**TESSMAN ROAD LANDFILL  
BEXAR COUNTY, TEXAS  
TCEQ PERMIT NO. MSW-1410C**

**PERMIT MODIFICATION**

**ABOVE GRADE CLASS 1 WASTE  
DISPOSAL OPTIONS**

Re: Permit Modification – Above Grade Class 1 Waste Disposal Options  
Tessman Road Landfill – Permit No. MSW-1410C  
Bexar County, Texas

NO.	DATE	DESCRIPTION										CHICAGO, IL NAPERVILLE, IL COLUMBUS, OH DENVER, CO		FORT WORTH, TX EVANSVILLE, IN RIVERSIDE, MO		GRAND RAPIDS, MI SOUTH BEND, IN SPRINGFIELD, IL CLEARMONT, FL		<b>FIGURE 1</b>
NO.	DATE	DESCRIPTION

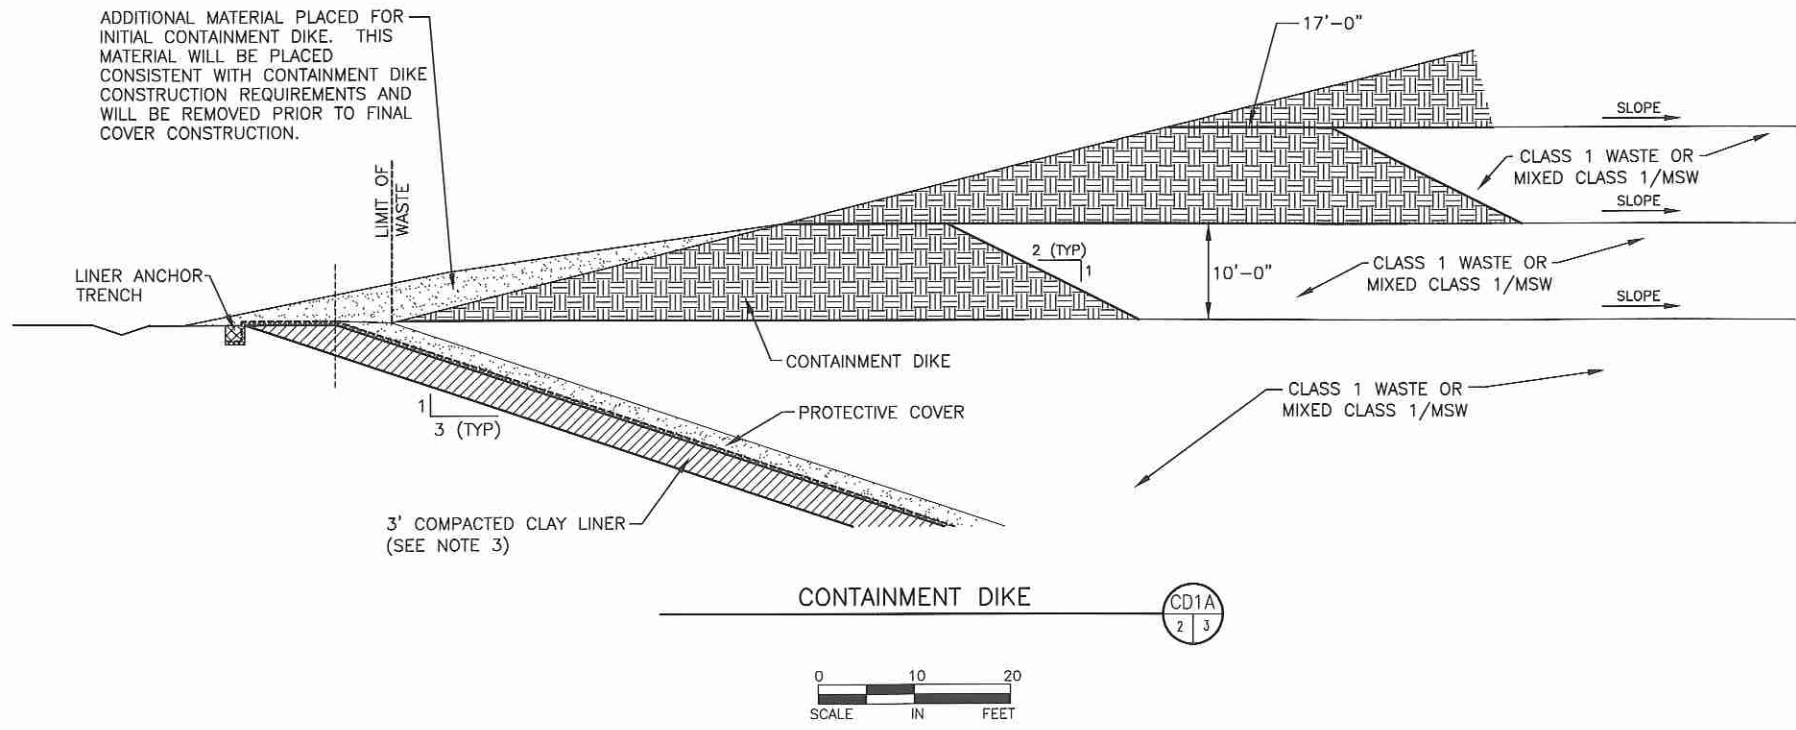
Figure 1 shows an existing site plan that indicates the current and future Class 1 waste disposal areas. As shown, about 9.5 acres of Class 1 disposal area have been constructed to date.

**NOTE:**  
 1. ABOVE GRADE CLASS 1 WASTE DISPOSAL MAY OCCUR IN THE EXISTING CONSTRUCTED CLASS 1 DISPOSAL AREA AND IN THE UNDEVELOPED AREAS OF PHASE IV, V, VI, AND VII IF A LINER SYSTEM IS CONSTRUCTED IN COMPLIANCE WITH 30 TAC §330.331(e).

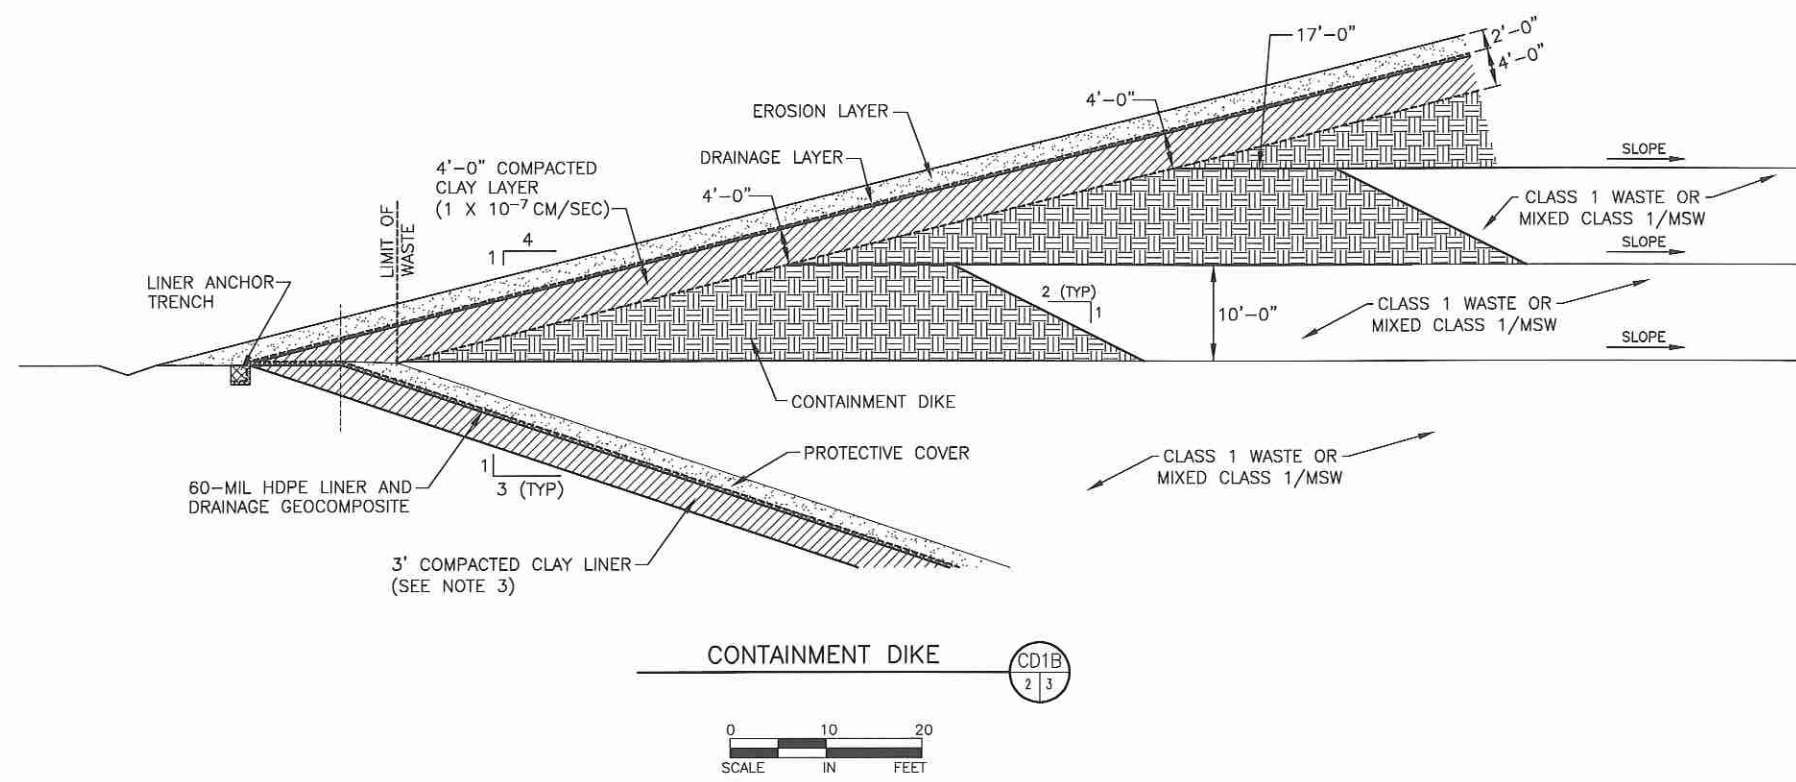
As shown on Figure 3, Class 1 waste will only be placed after a containment dike has been constructed. In addition, each lift of waste will be placed below the elevation of each containment dike and will slope toward the interior of the landfill.

- NOTES:**
1. CLASS 1 WASTE WILL BE DISPOSED OF ABOVE COMPACTED PERIMETER BERM GRADES WHEN CONTAINMENT DIKES ARE CONSTRUCTED. REFER TO APPENDIX III-F FOR MORE INFORMATION.
  2. CONTAINMENT DIKES WILL BE CONSTRUCTED IN AREAS WHERE THE DISPOSAL OF CLASS 1 WASTE WILL OCCUR ABOVE GRADE. THE CONTAINMENT DIKES WILL EXTEND ALONG THE BOTTOM OF FINAL COVER TO THE FINAL ELEVATION OF WASTE DISPOSAL.
  3. ALL AREAS WHICH RECEIVE CLASS 1 WASTE WILL HAVE A LINER SYSTEM CONSTRUCTED IN COMPLIANCE WITH 30 TAC §330.331(e).
  4. REFER TO APPENDIX III-F FOR INFORMATION REGARDING THE CONSTRUCTION OF CONTAINMENT DIKES.
  5. EACH CONTAINMENT DIKE OPTION IS ONLY APPLICABLE FOR
    - (1) THOSE AREAS CONSTRUCTED IN ACCORDANCE WITH §330.331(e) AND
    - (2) THE ALLOWABLE ABOVE GRADE CLASS 1 DISPOSAL AREAS SHOWN ON FIGURE 1.

- (REFER TO APPENDIX III-F OF THE SITE DEVELOPMENT PLAN)
- DIKES WILL BE CONSTRUCTED OF CLAY-RICH SOILS UNDER THE DIRECTION OF THE LANDFILL MANAGER OR HIS DESIGNEE.
  - SOILS WILL BE PLACED IN MAXIMUM 9-INCH THICK LIFTS AND COMPACTED WITH A MINIMUM OF FOUR PASSES WITH A DOZER OR SIMILAR EQUIPMENT.
  - UPON COMPLETION OF EACH DIKE, A THIRD PARTY INDEPENDENT PROFESSIONAL ENGINEER LICENSED TO PRACTICE IN TEXAS WILL CERTIFY THE INSTALLED DIKE IN ACCORDANCE WITH TITLE 30 TAC §335.590(24)(F)(vi) AND THE REQUIREMENTS INCLUDED IN APPENDIX III-F OF THE SDP PRIOR TO PLACEMENT OF WASTE. THE LICENSED ENGINEER WILL UTILIZE THE CURRENT VERSION OF THE STANDARD FORM INCLUDED IN §335.590(24)(F)(vi) FOR THE CERTIFICATION OF THE DIKE. THE CERTIFICATION PREPARED AND SIGNED BY THE ENGINEER WILL BE PLACED IN THE SITE OPERATING RECORD.

O:\0120\109\CLASS 1 WASTE MOD\ATT 1\FIG 1-1 SITE LAYOUT PLAN.dwg, 12/7/2011 1:57:48 PM, f.sellers

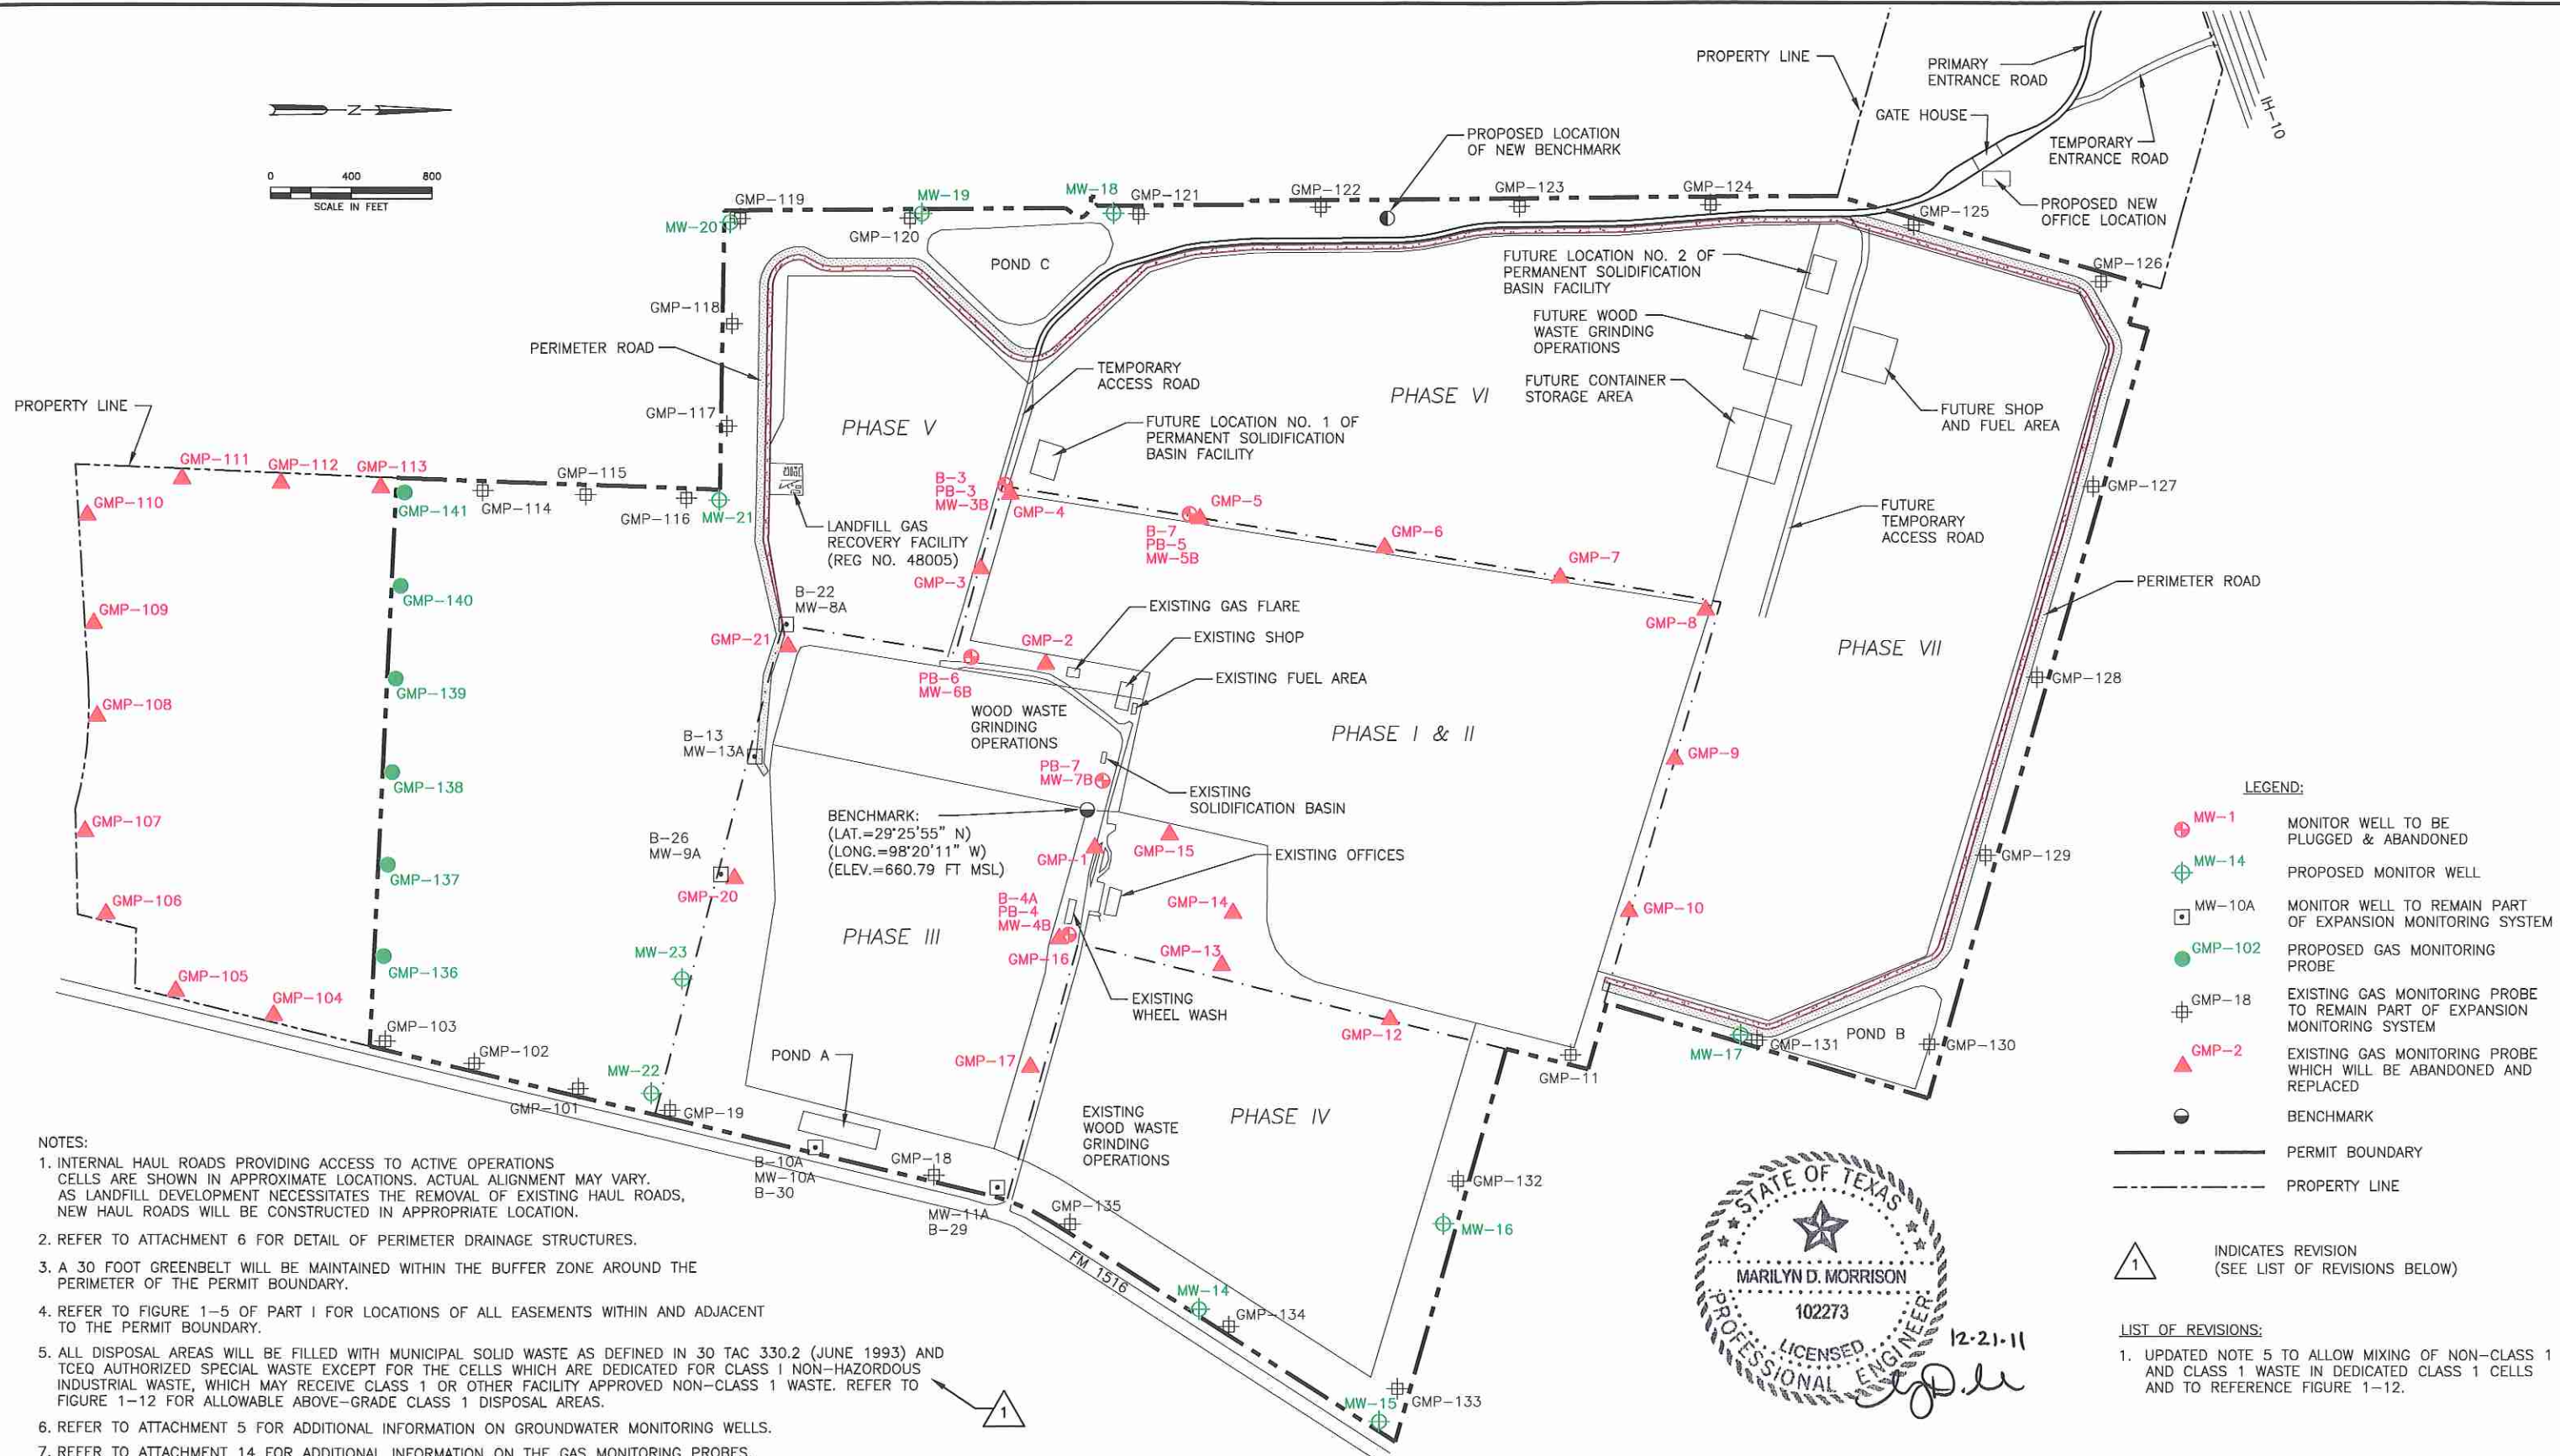
- REFER TO FIGURE 1-5 OF PART I FOR LOCATIONS OF ALL EASEMENTS WITHIN AND ADJACENT TO THE PERMIT BOUNDARY.
- ALL DISPOSAL AREAS WILL BE FILLED WITH MUNICIPAL SOLID WASTE AS DEFINED IN 30 TAC 330.2 (JUNE 1993) AND TCEQ AUTHORIZED SPECIAL WASTE EXCEPT FOR THE CELLS WHICH ARE DEDICATED FOR CLASS 1 NON-HAZARDOUS INDUSTRIAL WASTE, WHICH MAY RECEIVE CLASS 1 OR OTHER FACILITY APPROVED NON-CLASS 1 WASTE. REFER TO FIGURE 1-12 FOR ALLOWABLE ABOVE-GRADE CLASS 1 DISPOSAL AREAS.

- UPDATED NOTE 5 TO ALLOW MIXING OF NON-CLASS 1 AND CLASS 1 WASTE IN DEDICATED CLASS 1 CELLS AND TO REFERENCE FIGURE 1-12.

CONTAINMENT DIKE CD1A  
2-1 THROUGH 2-6, 7-3 THROUGH 7-8 12-7

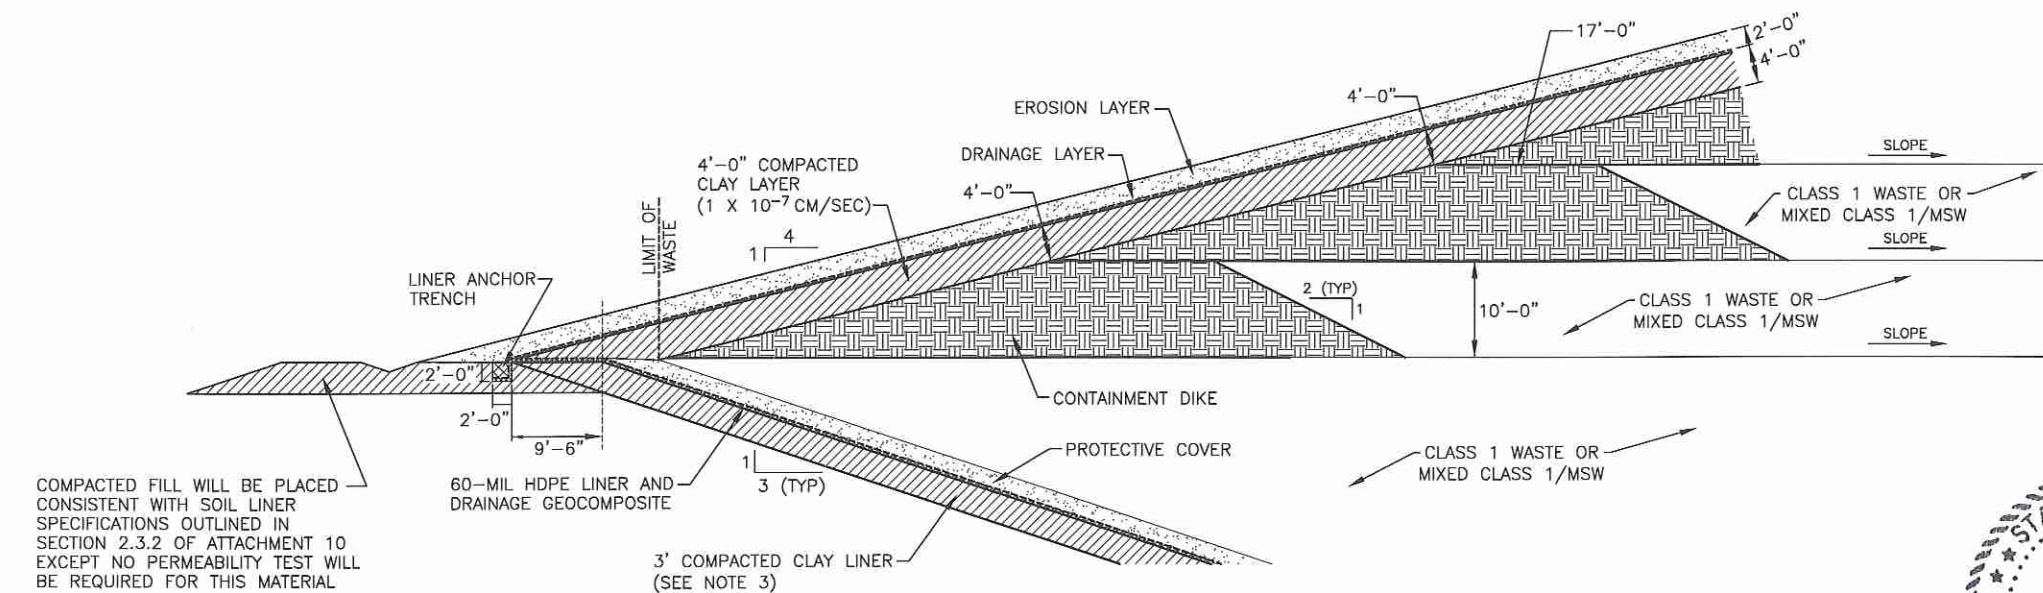
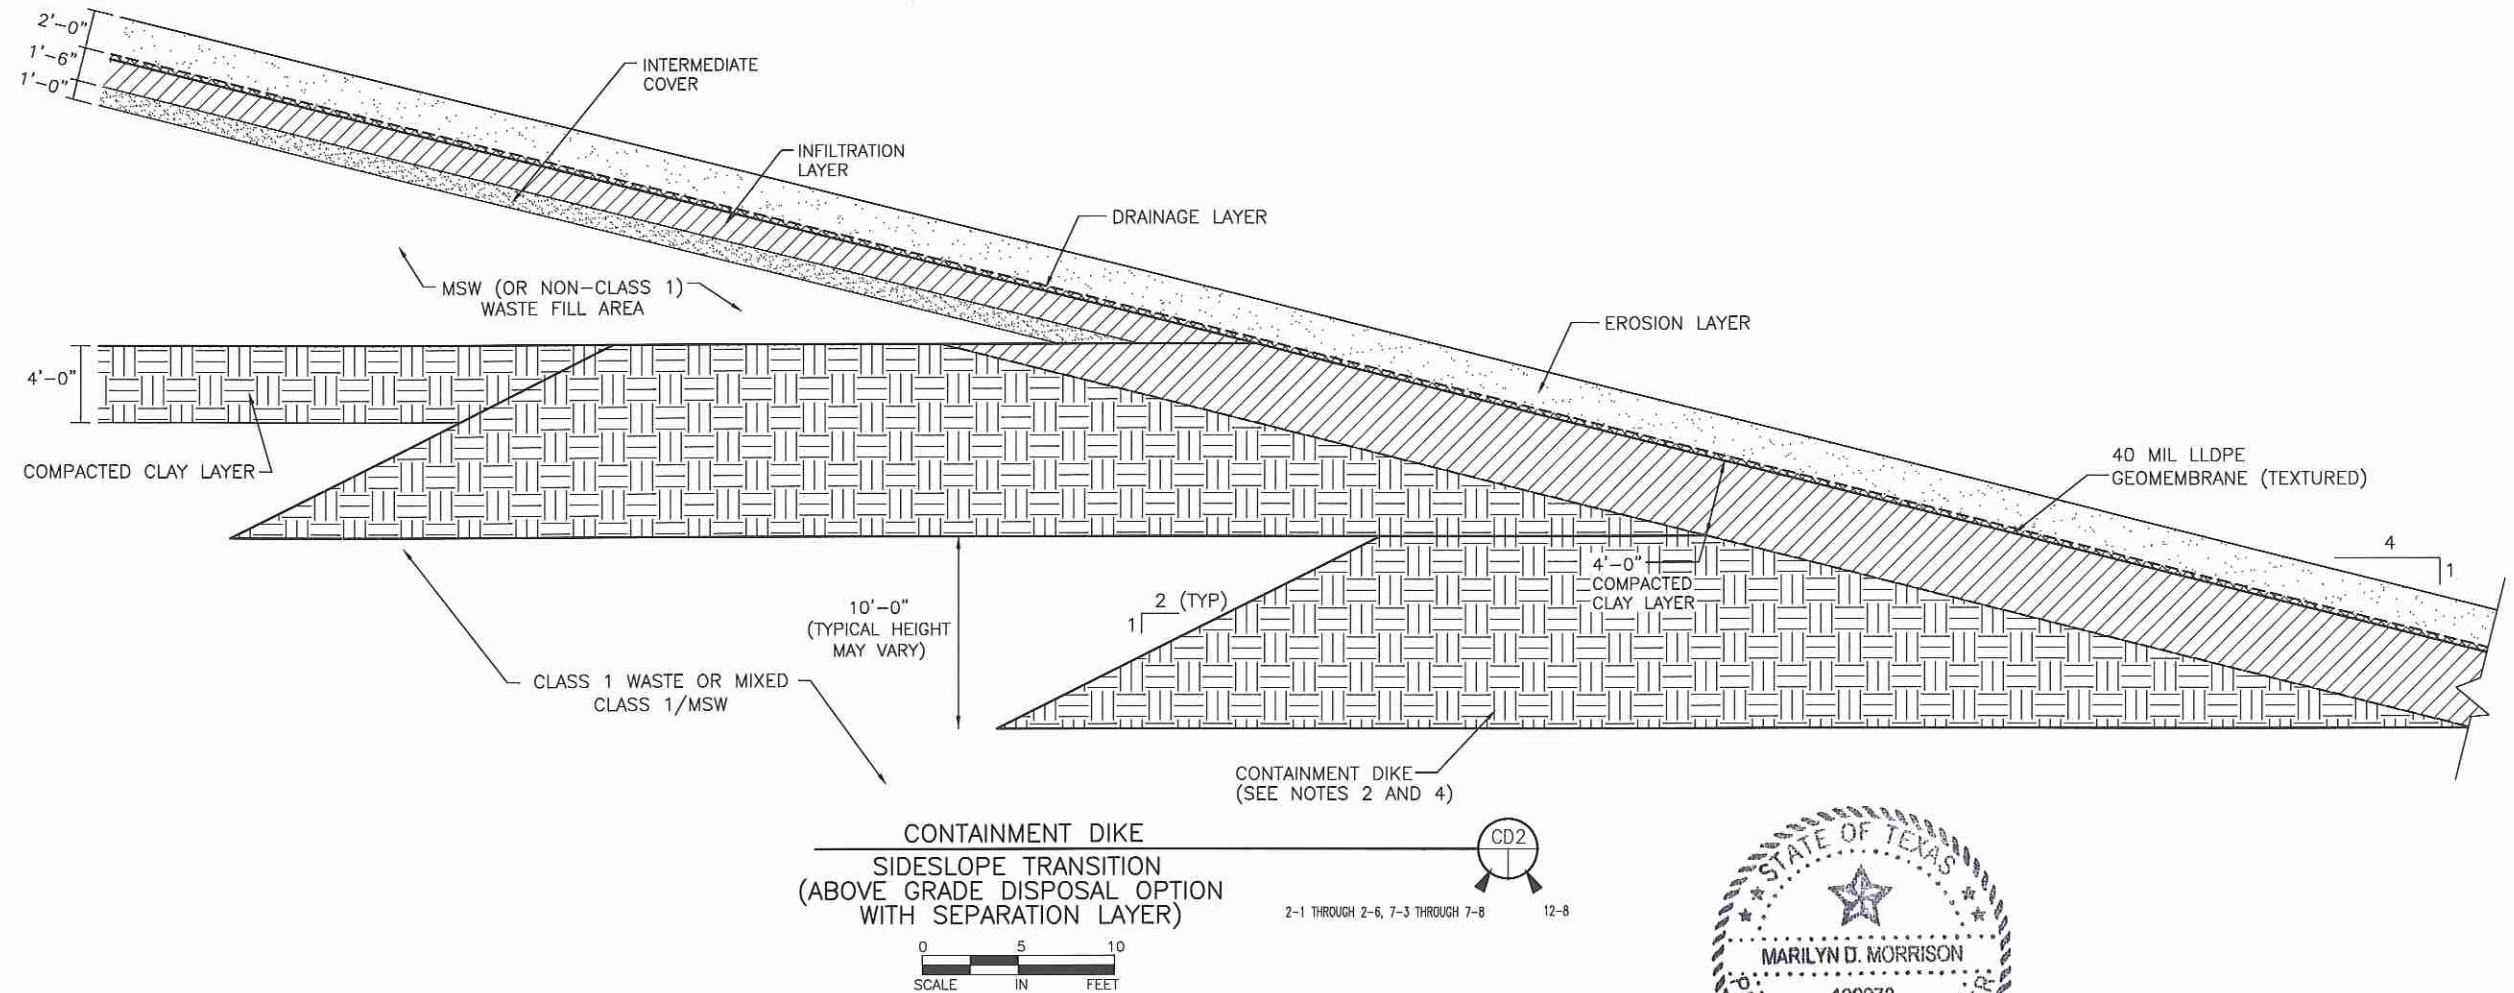
As shown on Figure 12-7 in Attachment 12, Class 1 waste will only be placed after a containment dike has been constructed. In addition, each lift of waste will be placed below the elevation of each containment dike and will slope toward the interior of the landfill.

1. CLASS 1 WASTE WILL BE DISPOSED OF ABOVE COMPACTED PERIMETER BERM GRADES WHEN CONTAINMENT DIKES ARE CONSTRUCTED. REFER TO APPENDIX III-F FOR MORE INFORMATION.
2. CONTAINMENT DIKES WILL BE CONSTRUCTED IN AREAS WHERE THE DISPOSAL OF CLASS 1 WASTE WILL OCCUR ABOVE GRADE. THE CONTAINMENT DIKES WILL EXTEND ALONG THE BOTTOM OF FINAL COVER TO THE FINAL ELEVATION OF WASTE DISPOSAL.
3. ALL AREAS WHICH RECEIVE CLASS 1 WASTE WILL HAVE A LINER SYSTEM CONSTRUCTED IN COMPLIANCE WITH 30 TAC §330.331(e).
4. REFER TO APPENDIX III-F FOR INFORMATION REGARDING THE CONSTRUCTION OF CONTAINMENT DIKES.
5. EACH CONTAINMENT DIKE OPTION IS ONLY APPLICABLE FOR
  - (1) THOSE AREAS CONSTRUCTED IN ACCORDANCE WITH §330.331(e) AND
  - (2) THE ALLOWABLE ABOVE GRADE CLASS 1 DISPOSAL AREAS SHOWN ON FIGURE 1-12 IN ATTACHMENT 1.

The containment dike construction requirements are listed below (and also summarized on-Figure 12-7 in Attachment 12.
